Intersection ID: 10042371	Main Street: WYALONG_DR	Cross Street: N/A	Location:	SE
ADA ID: A3B963AF25E4	Ramp Type: BlendTrans1	Initial Pass/Fail: Fail	Overall Compliance: No	Severity Score: 1.25

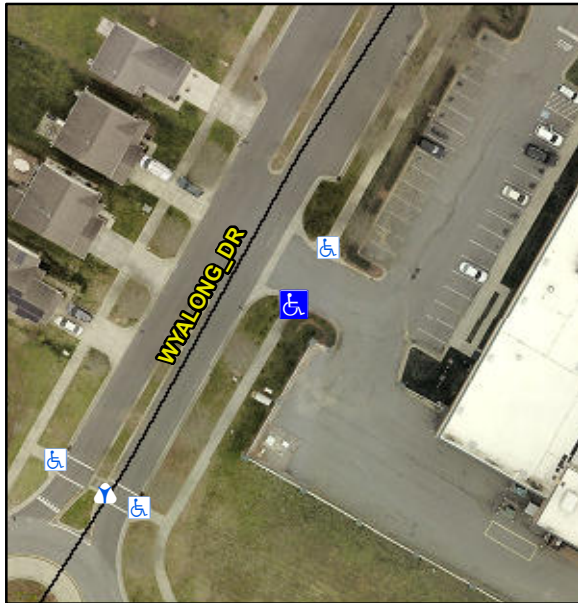
Compliance	Description	Data	Compliance	Description	Data
N/A	Ramp Length (in)	96.0	Yes	BlendTrans Slope (%)	4.2
Yes	Ramp Width (in)	76.5	No	BlendTrans XSlope (%)	2.3
N/A	Flare Type LT	N/A	N/A	Flare Type RT	N/A
N/A	Flare Slope LT (%)	N/A	N/A	Flare Slope RT (%)	N/A
N/A	Flare Traversable LT?	N/A	N/A	Flare Traversable RT?	N/A
N/A	Landing Length (in)	N/A	N/A	DWS Provided?	N/A
N/A	Landing Width (in)	N/A	N/A	DWS Contrast?	N/A
N/A	Landing Slope (%)	N/A	N/A	DWS Length (in)	N/A
N/A	Landing X Slope (%)	N/A	N/A	DWS Full Width?	N/A
N/A	Landing Curb? (Y/N)	N/A	N/A	DWS Offset (in)	N/A
N/A	Shared Landing?	N/A			
N/A	Gutter Ponding?	N/A	N/A	Gutter Slope (%)	N/A
N/A	Gutter Lip Ht (in)	N/A	N/A	Gutter X Slope (%)	N/A
N/A	Painted X Walk1?	No	N/A	Painted X Walk2?	N/A
	X Walk 1 Direction	To NE		X Walk 2 Direction	N/A
	X Walk 1 Width (in)	N/A		X Walk 2 Width (in)	N/A
	X Walk 1 Slope (%)	0.8		X Walk 2 Slope (%)	N/A
	X Walk 1 X Slope (%)	0.2		X Walk 2 X Slope (%)	N/A

N/A	Ramp inside XWalk1?	N/A	N/A	Ramp inside XWalk2?	N/A
	Road Slope (%)	0.2		Clear Space?	N/A
	Road X Slope (%)	0.8	N/A	Clear Space to XWalk (in)	N/A
N/A	Any Obstructions?	N/A	N/A	Storm Grate/Utility Hazard?	N/A
	Obstruction Type			Storm Grate/Utility Type	
		N/A			N/A
			Yes	Surface Condition? (G/P)	Good
			N/A	Curb Slope (%)	1.4

Remove & Replace Curb Ramp With Two New Directional Ramps or Equivalent.

R304.5.3
